To: Kristopher Byrd, Well Construction Manager
From: Tommy Laird, Well Construction Program Coordinator
Subject: Review of Water Right Application G-19348
Date: January 9, 2024

Groundwater Application Review Summary Form

Application # G- 19348

TO: Water Rights Section Date 12/20/2023
 FROM: Groundwater Section Joe Kemper
Reviewer's Name
 SUBJECT: Application G- 19348 Supersedes review of na
Date of Review(s)

CITY OF REDMOND WELL #7 AS BUILT

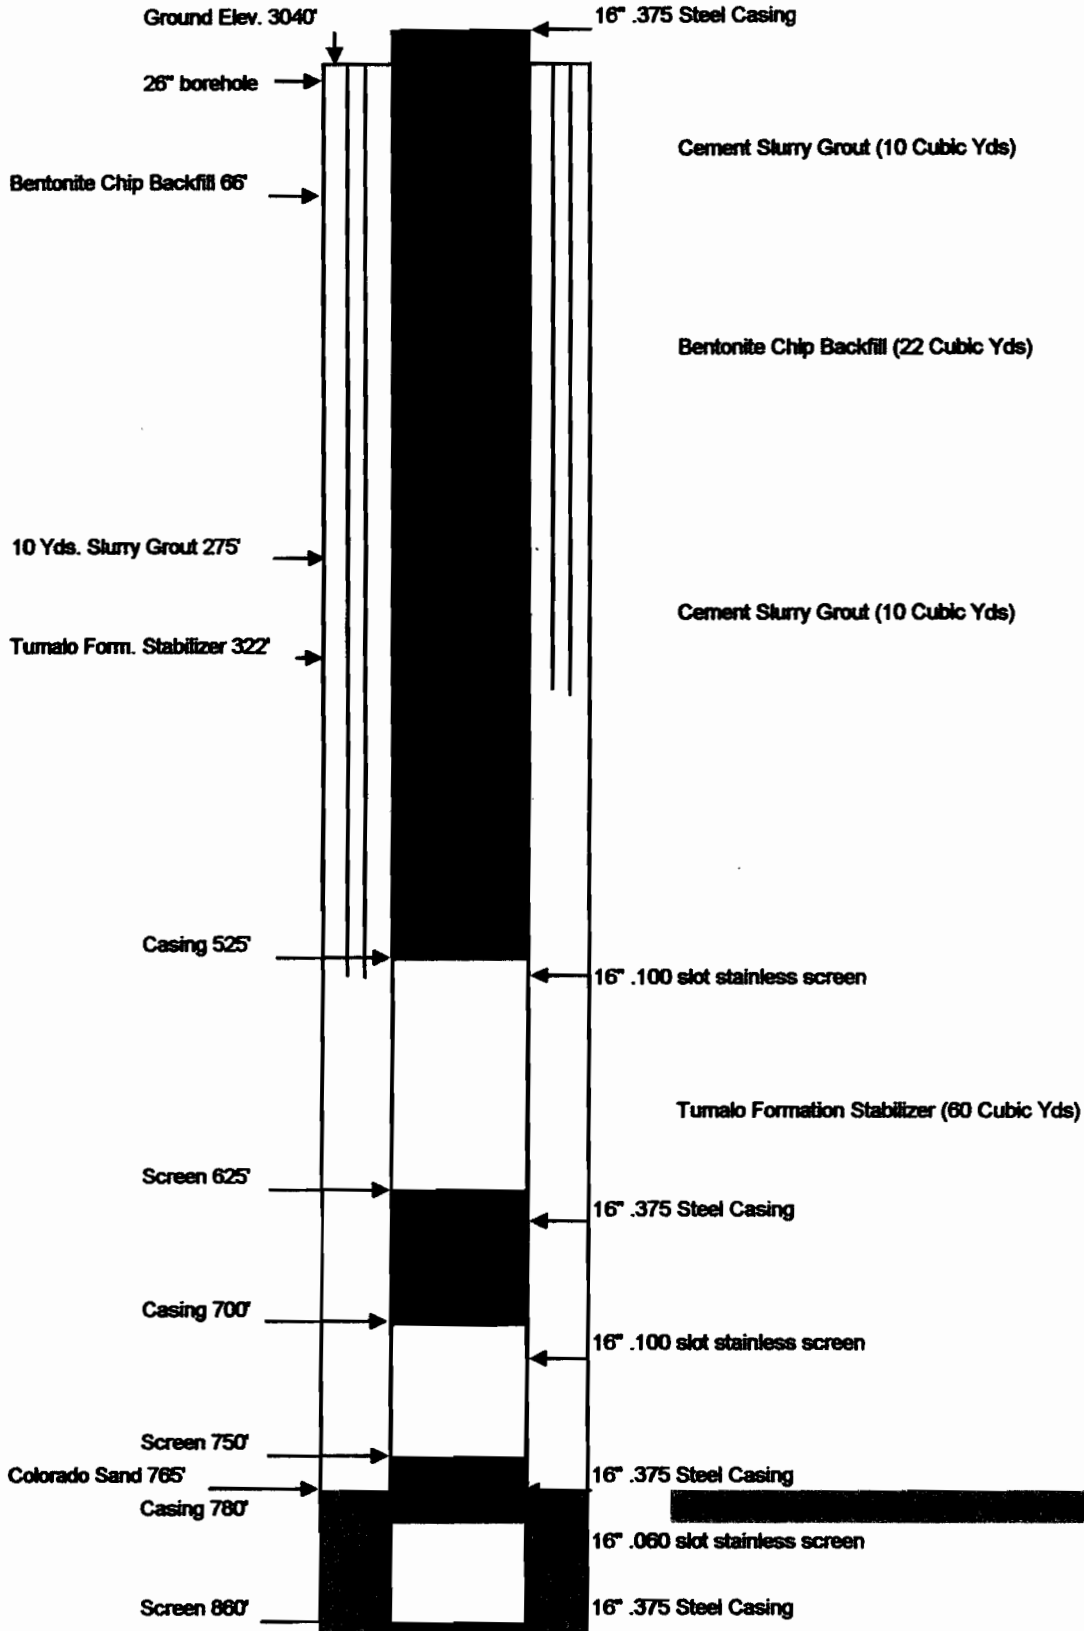
Applicant's Well #7 (DESC 57788): Based on a review of the Well Report, Applicant's Well #7 seems to protect the groundwater resource.

The construction of Applicant's Well #7 may not satisfy hydraulic connection issues or the Groundwater Application Review Special Conditions.

Map of Hole

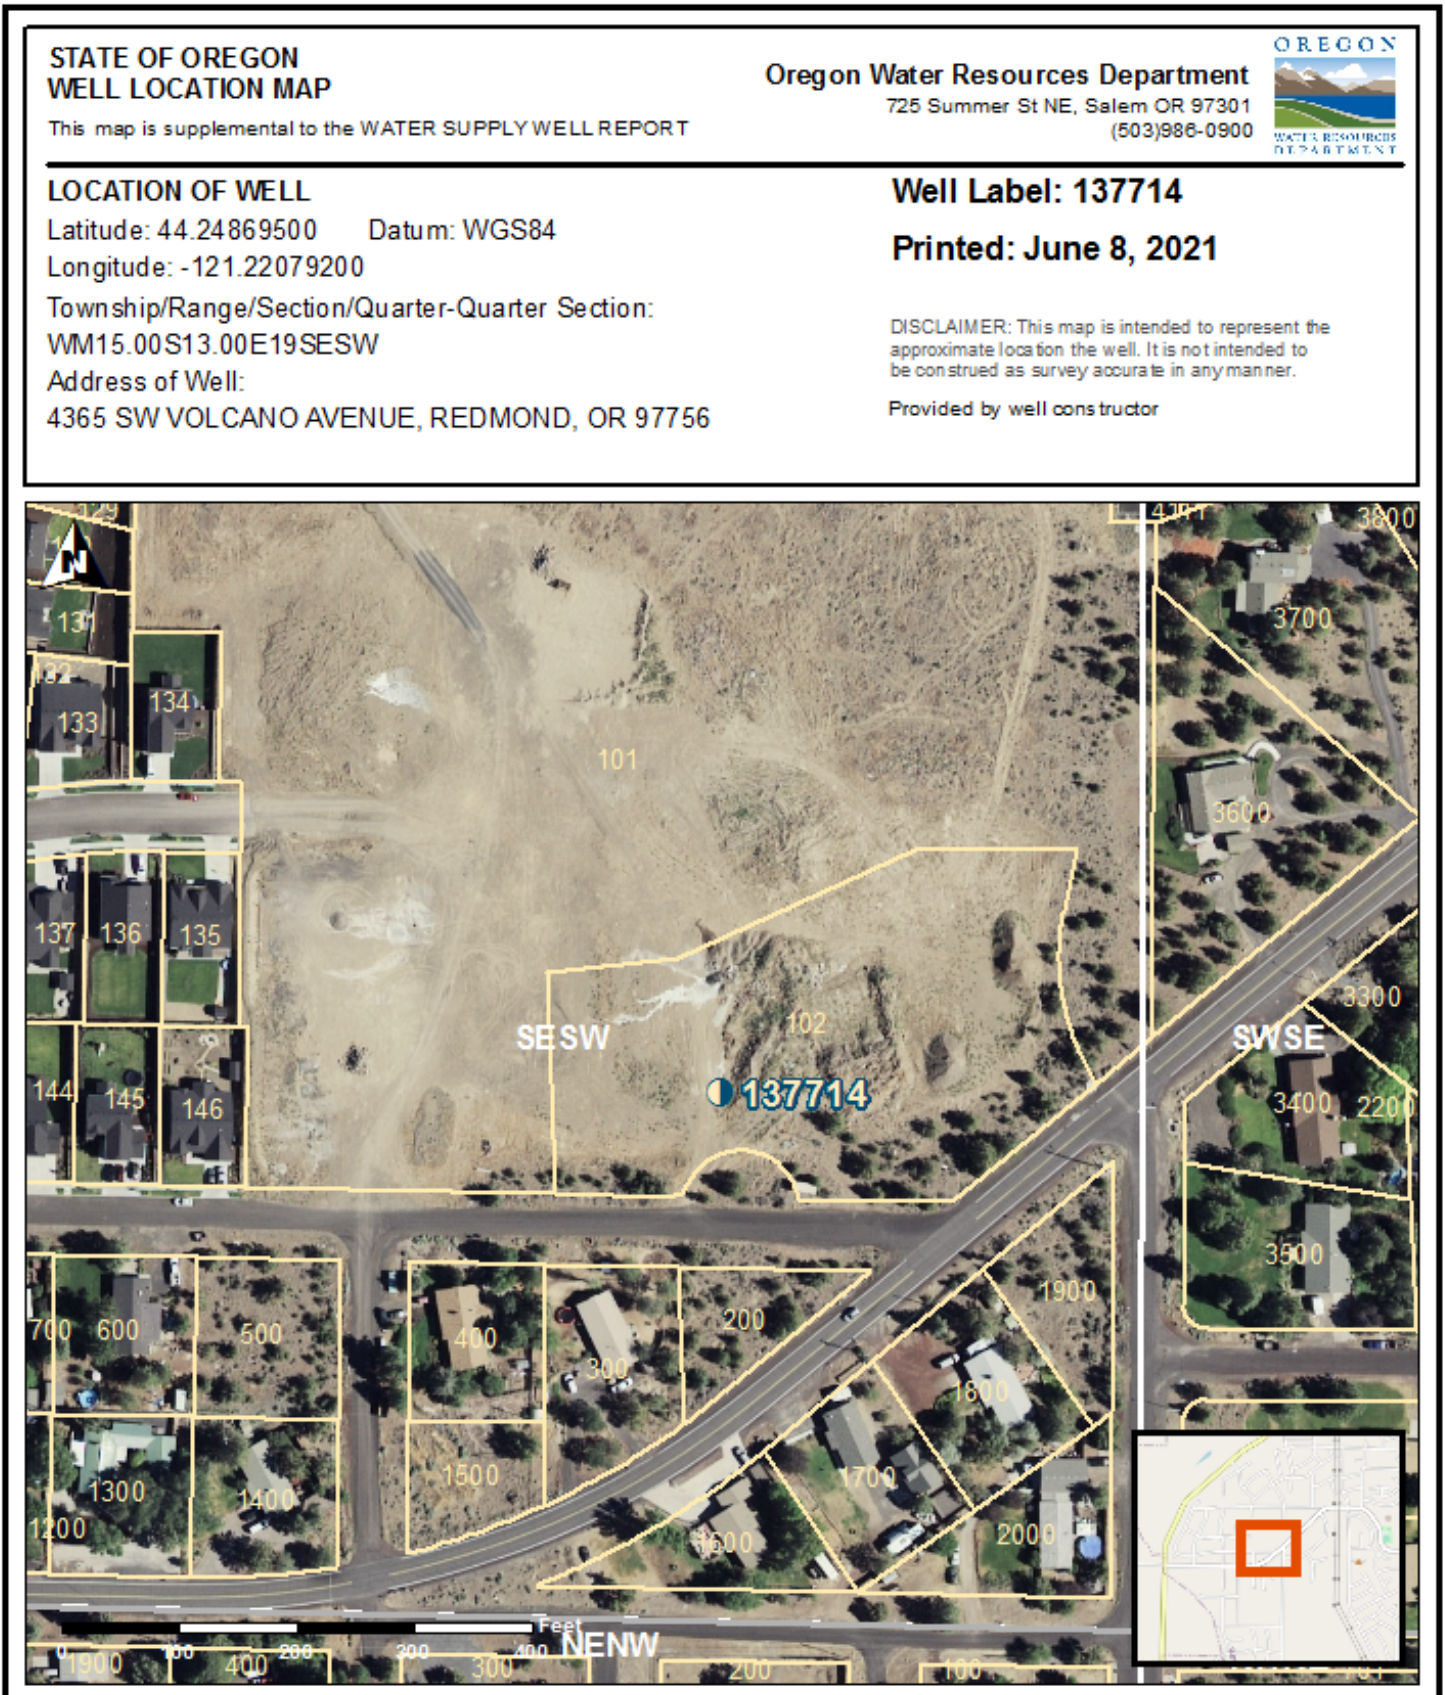
Applicant's Well #8 (DESC 62721): Based on a review of the Well Report, Applicant's Well #8 seems to protect the groundwater resource.

The construction of Applicant's Well #8 may not satisfy hydraulic connection issues or the Groundwater Application Review Special Conditions.
